## Department of Transportation

#### MEMORANDUM

**SUBJECT:** ZC Case No. 06-11Q/06-12Q/01-17E/06-11R – 2025 F Street NW (George Washington University Thurston Hall)

Figure 1 – Site Design and Access (Source: Gorove Slade October 18, 2019 CTR, Figure 6)

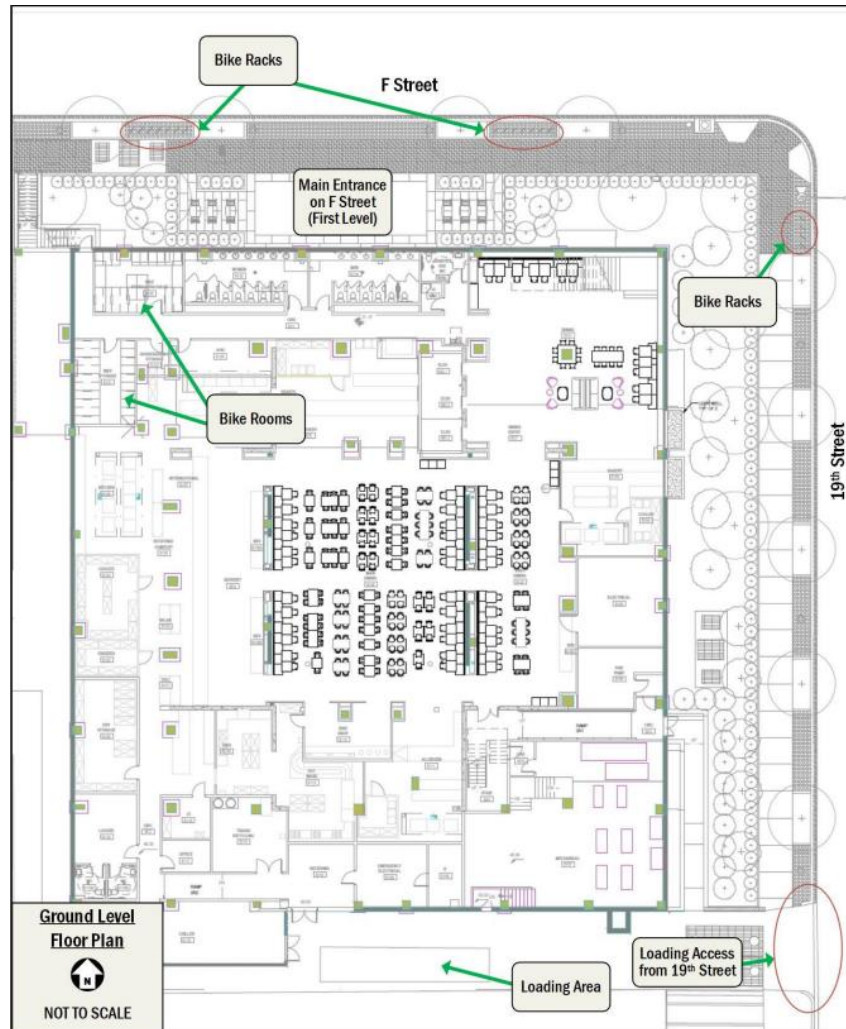
- The below grade dining space requires two (2) points of emergency egress: one on F Street NW and the other on 19<sup>th</sup> Street NW. These areaways project beyond 6.5 feet and do not comply with public space regulations. The Applicant should reduce the areaways as much as possible, but will likely need to apply for a code modification with DCRA.
- The new light wells on 19<sup>th</sup> Street NW appear to meet the areaway projection requirements.
- There is an existing berm around the site that should not be regarded with the exception of the new seating area on F Street NW. Any retaining walls in the sitting area should not be taller than the existing grade they are retaining.
- Any special paving at the entrance will require a Covenant of Maintenance.

- The sidewalk materials should show brick on F Street NW and concrete on 19<sup>th</sup> Street NW.
- The bike racks will need to be positioned in such a way to ensure the wheels do not project into the pedestrian clear path.
- Existing parking meters may be required to be upgraded to multi-space meters at the Applicant’s expense.
